FEDERAL ENERGY REGULATORY COMMISSION

I am pleased to enclose a copy of our Operation Inspection Report for DOE-Rocky Flats Dams A-4 B-5 and C-2 The field inspection of these dams was conducted on September 21 1994

Operation Inspection Report
for
Department of Energy

Dam Name Dams A-4, B-5 & C-2

Photo 10 View of Outlet Works Channel Full of vegetation

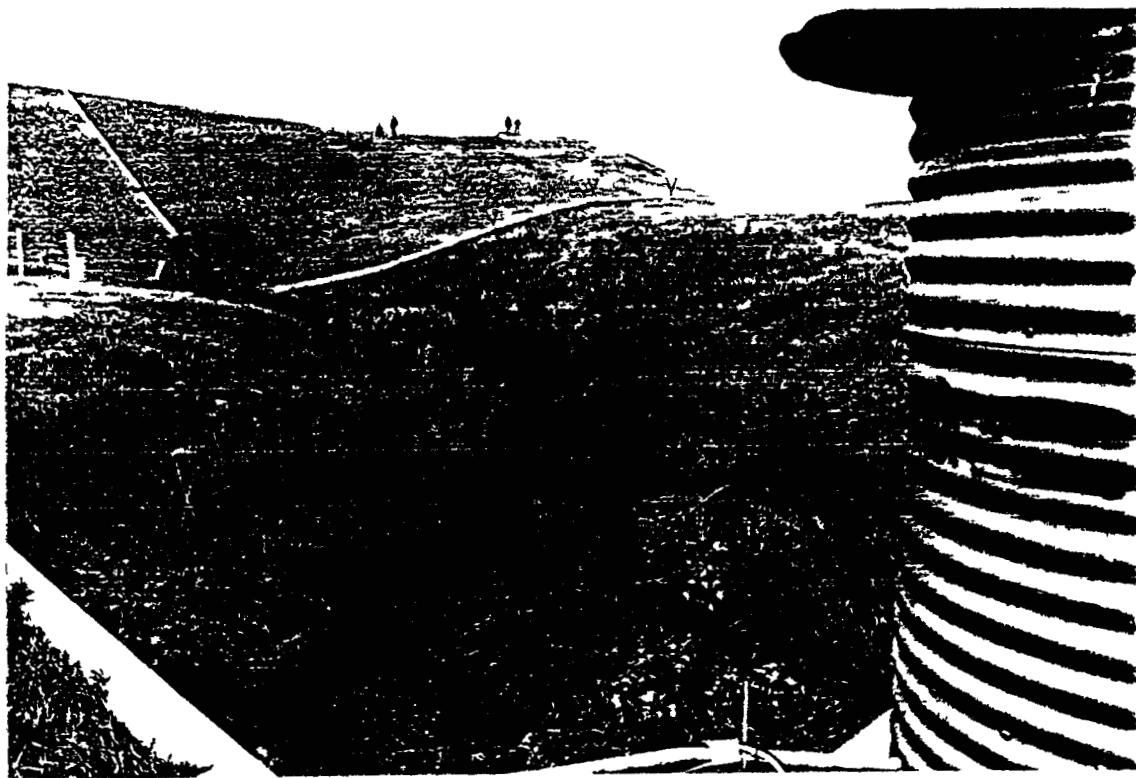
The outlet works consists of an 18-inch (46 cm) reinforced concrete pipe (RCP) which discharges into a concrete stilling basin. Heavy vegetative growth in and around the outlet structure (Photo 9) prevented the observation of any telltale signs of piping around the outlet pipe. The visible portion of the structure however appeared in a good condition. No cracks or spalls in the concrete were noted. The outlet works channel also had heavy vegetation growth (Photo 10). The shut-off gate is located at the downstream end of the conduit. This is not a desirable feature since the conduit is continuously pressurized which greatly increases the risk of leakage through pipe joints which could cause piping along the outside of the conduit.

(1) Heavy vegetation growth in the outlet structure area prevents proper inspection for piping along the outlet pile. This as well as vegetation on the upstream face near the crest level should be cut back.

Photo 14 View of the Outlet Works of Pond B-5 Dam looking north east

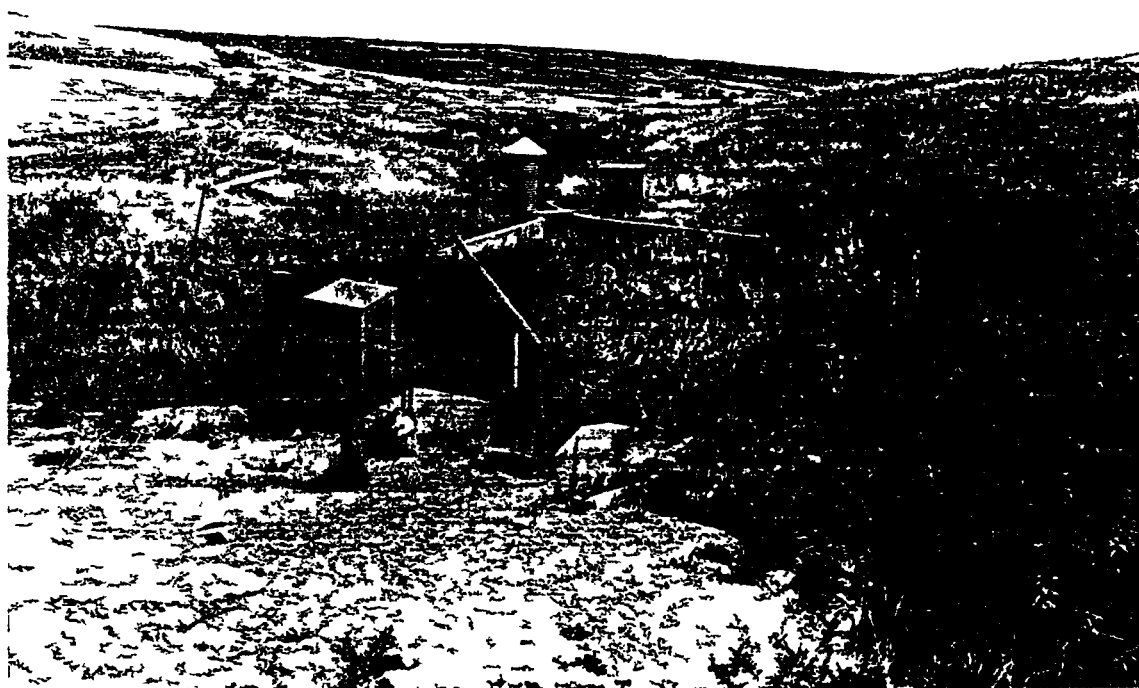
As for Dam A-4, excessive vegetation was also observed near the outlet area and the channel (Photos 14 & 15) The concrete of the outlet structure appeared to be in a good condition

(1) Excessive vegetation growth exists in and around the outlet structure. It should be cut back.

1994 Elevations of Pond A-4 and Piezometers

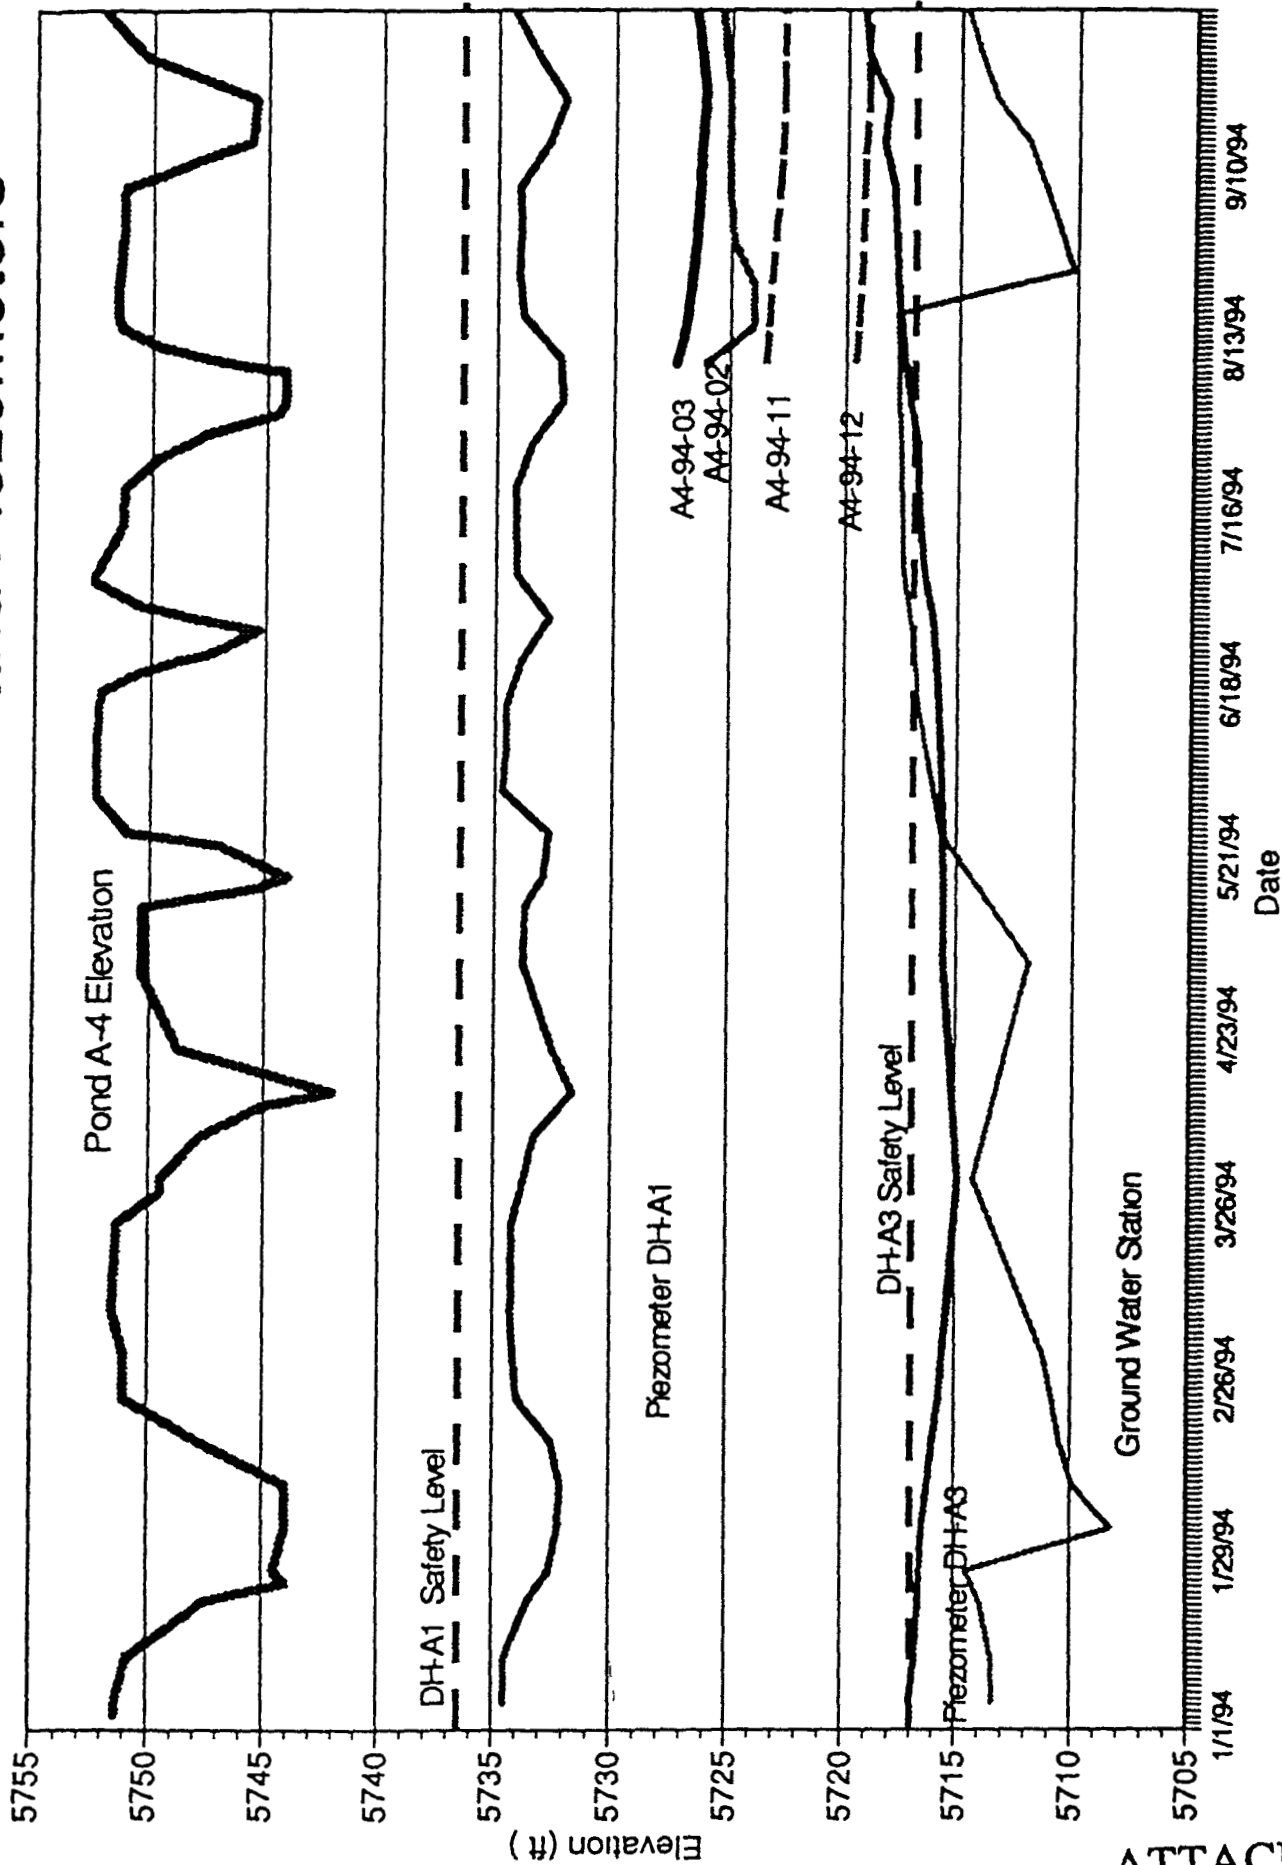
Dam A-4 Four new piezometers were installed in July 1994 Two of these A4-94-02 and A4-94-03 are at the crest and the other two A4-94-11 and A4-94-12 are at the toe of the dam Enough data from these four piezometers have not been collected to indicate any definite correlation with the pond level In fact during the period of 8/8/94 to 8/15/94 the reservoir level rose by 7 feet, but the piezometer readings did not respond Actually for A4-94-03 it went down by a couple of feet We shall need to have more data before any conclusions can be drawn Perhaps the instruments also need to be checked to see if these are functioning properly

The reservoir levels indicate that the reservoir was being operated at substantially higher capacity and over a longer period of time during the data period than originally intended The highest elevation has been as high as 54% full

1994 Elevations of Pond B-5 and Crest Piezometers

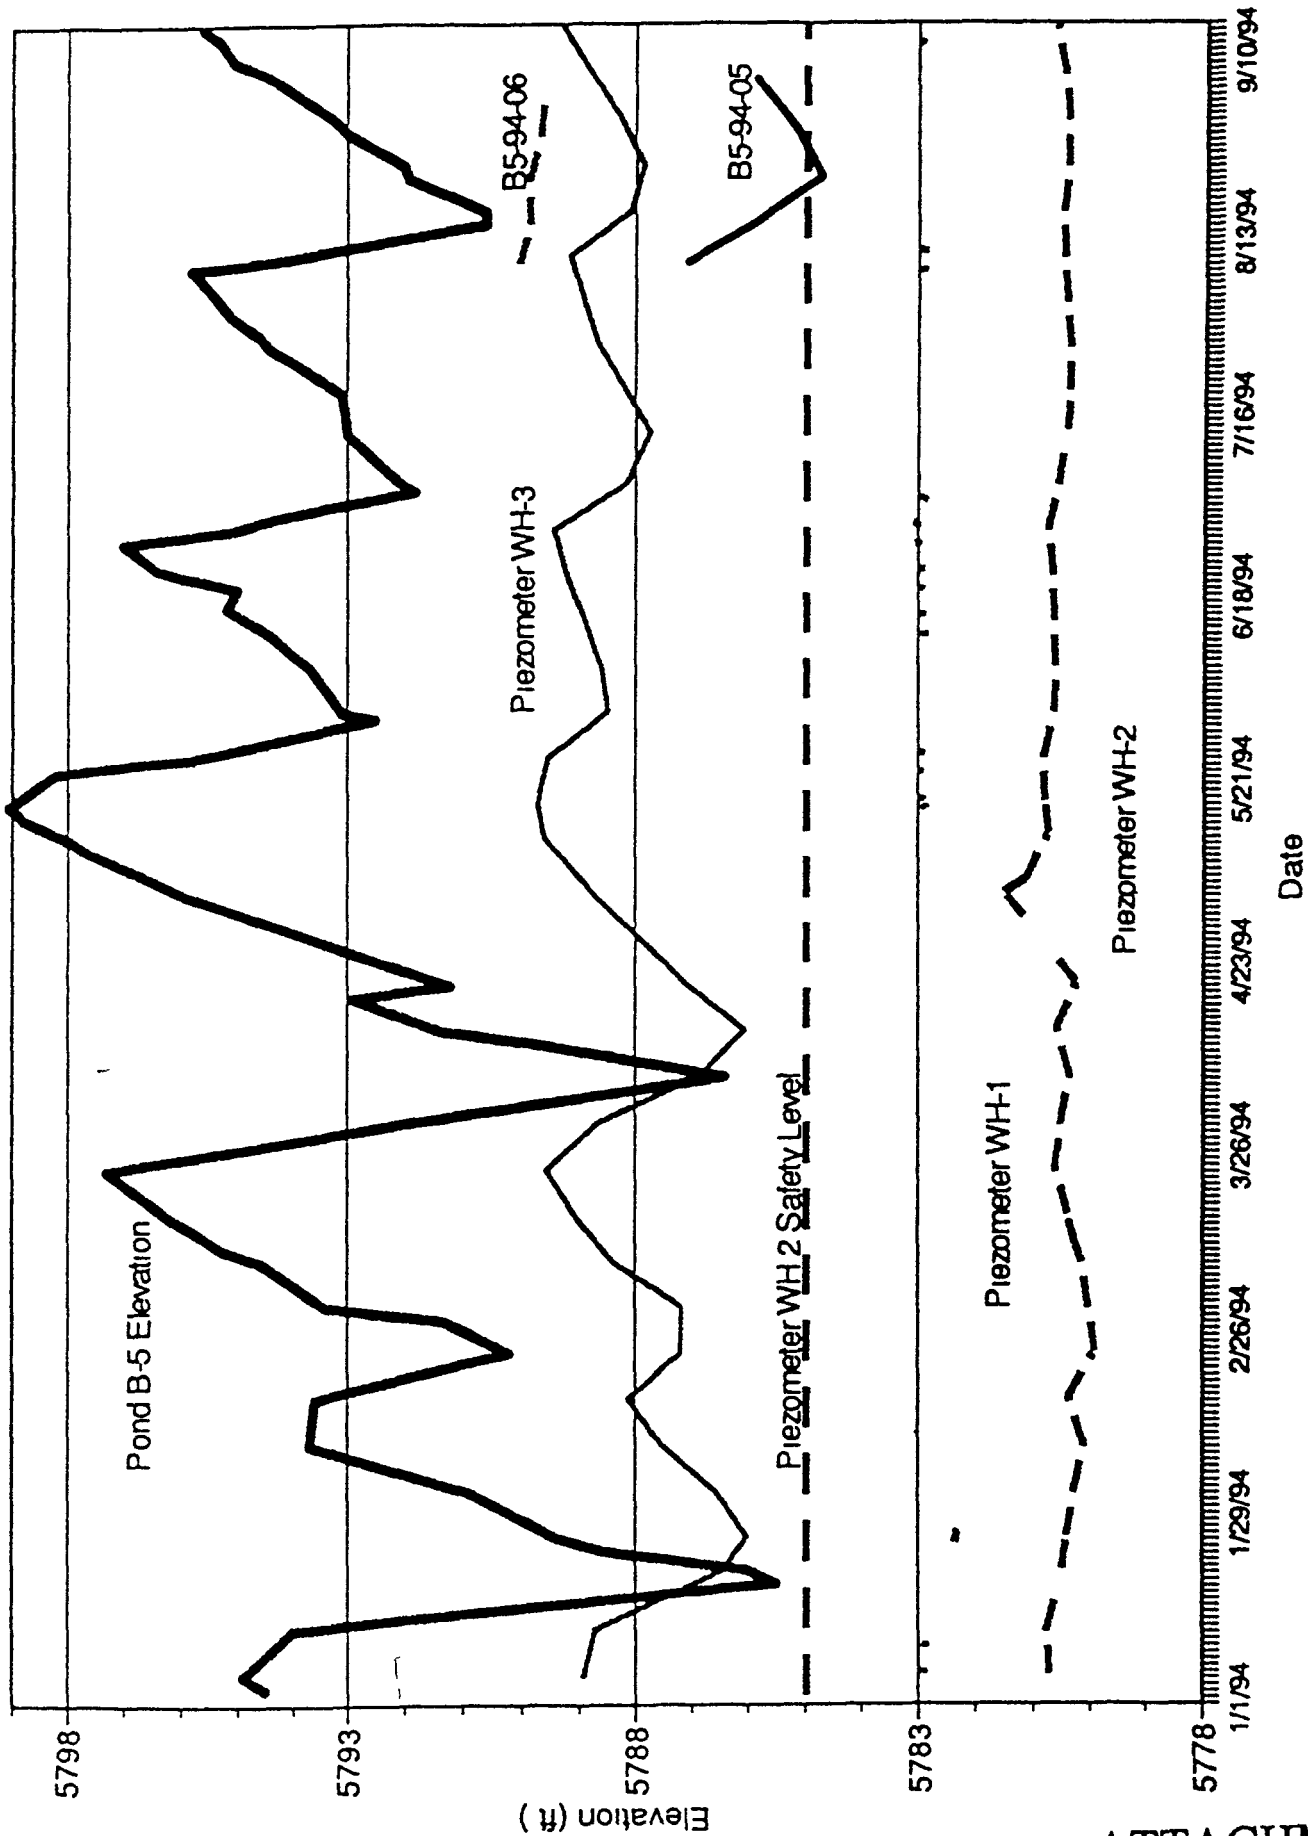
Dam B-5 Three new piezometers were installed in June 1994 Two of these B-5-94-05 and B5-94-06 are at the crest and the third B5-94-11 is at the toe of the dam See Photo 24 for installed piezometers inclinometers and remote telemetry system As for Dam A-4 very little data are available for these piezometers to arrive at any conclusions Readings for B5-94-06 appear to be going down as the pond level goes up Pressure readings for B5-94-05 appear to follow the pond level variation

As for Dam A-4 the reservoir levels indicate that the reservoir was being operated at higher capacity than originally intended The highest elevation has been as high as 60% full
